Access Compliance Report

Public Rights-of-Way

Intersection ID: 19055	Main Street: MONROE_RD	Cross Street: LUMARKA_DR	Location: NE
ADA ID: 9509EBEC07B7	Ramp Type: PerpDiag	Initial Pass/Fail: Fail	Overall Compliance: No
Codes/Mitigation Info/Possible Solution		Field Measurements/Component Compliance

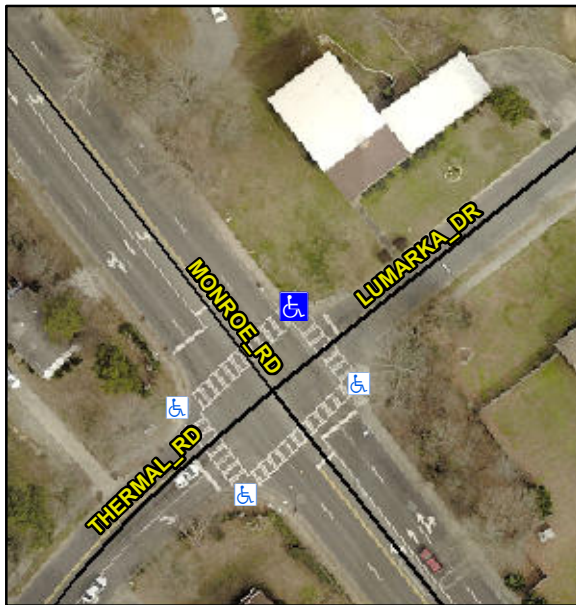
Not Found, R304.5.1, R304.2.2, R304.5.3

Compliance	Description	Data	Compliance	Description	Data
N/A	Ramp Length (in)	58.0	No	Ramp Slope (%)	9.5
No	Ramp Width (in)	40.0	No	Ramp XSlope (%)	5.9
N/A	Flare Type LT	N/A	N/A	Flare Type RT	N/A
N/A	Flare Slope LT (%)	N/A	N/A	Flare Slope RT (%)	N/A
N/A	Flare Traversable LT?	N/A	N/A	Flare Traversable RT?	N/A
N/A	Landing Length (in)	N/A	N/A	DWS Provided?	N/A
N/A	Landing Width (in)	N/A	N/A	DWS Contrast?	N/A
N/A	Landing Slope (%)	N/A	N/A	DWS Length (in)	N/A
N/A	Landing X Slope (%)	N/A	N/A	DWS Full Width?	N/A
N/A	Landing Curb? (Y/N)	N/A	N/A	DWS Offset (in)	N/A
N/A	Shared Landing?	N/A			
N/A	Gutter Ponding?	N/A	N/A	Gutter Slope (%)	N/A
N/A	Gutter Lip Ht (in)	N/A	N/A	Gutter X Slope (%)	N/A
N/A	Painted X Walk1?	Yes	N/A	Painted X Walk2?	Yes
	X Walk 1 Direction	To SW		X Walk 2 Direction	To SE
N/A	X Walk 1 Width (in)	112.0	N/A	X Walk 2 Width (in)	100.0
	X Walk 1 Slope (%)	0.9		X Walk 2 Slope (%)	1.9
	X Walk 1 X Slope (%)	2.5		X Walk 2 X Slope (%)	0.9

Remove & Replace Curb Ramp With Two New Directional Ramps or Equivalent.
